INTERIM CHANGE NOTICE (ICN)

A. Document No.: PNNL-13612 Revision No.: 1		Effective Date of ICN: 7/20/03
Document Title: Groundwater Quality Assessment Plan for Single-Shell Tank Waste Management Area U		Change Requested By: R. M. Smith
Document's Original Author: R. M. Smith, F. N. Hodges, B. A. Williams

C. Effect of Change: This ICN updates the assessment plan to reflect the current wells in the monitoring system and the current constituent list and sampling schedule for WMA U.

Figure 2.1. Waste Management Area U and Regulated Structures

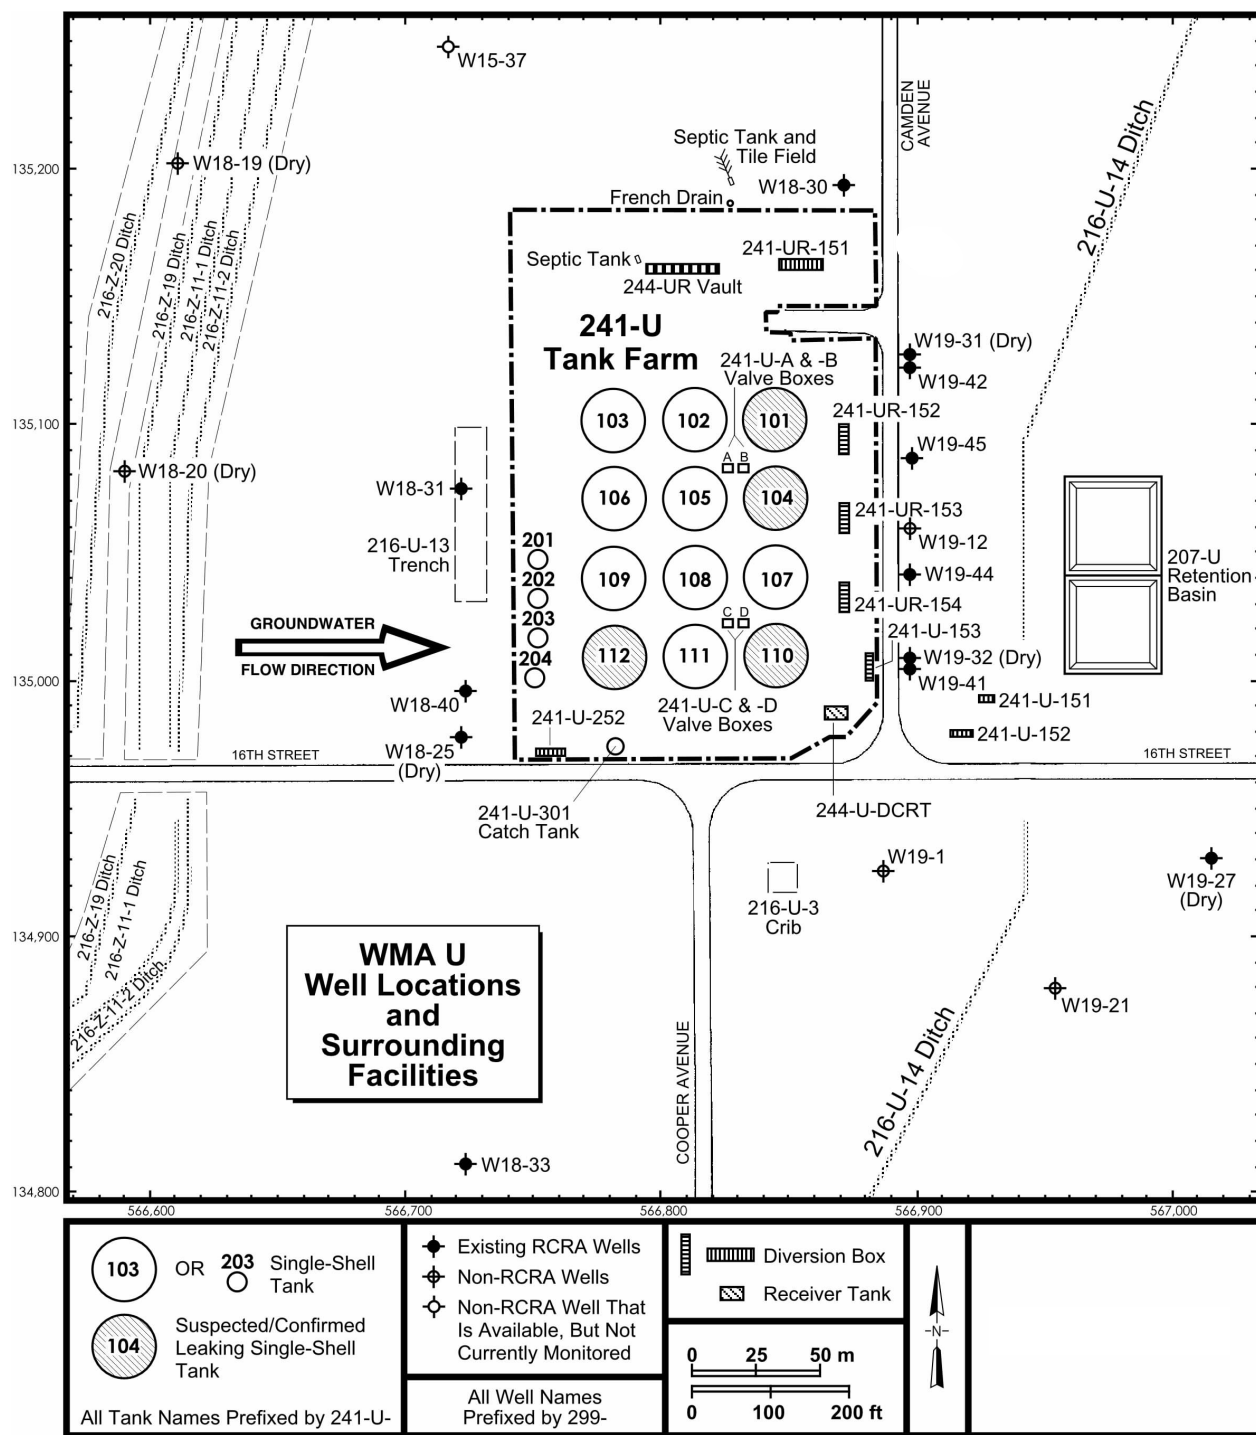
D. Reason for Change/Description of Change: Reason for Change: New wells have been constructed at WMA U and the constituent list has been modified to reflect constituents with a source in the WMA. Constituents present in groundwater beneath the WMA that are part of a regional plume with a source other than the WMA have been removed from the constituent list. These plumes will be monitored within the UP-1 and ZP-1 Operable Units. Description of Change: 1. Replace page 5 of the original document with the attached page 5 which shows a revised Figure 2.1. 2. Replace page 31 of the original document with the attached page 31 which shows a revised Table 5.2. 3. Add well construction and completion summaries for new wells 299-W18-40, 299-W19-44, and 299-W19-45 to the end of Appendix B.
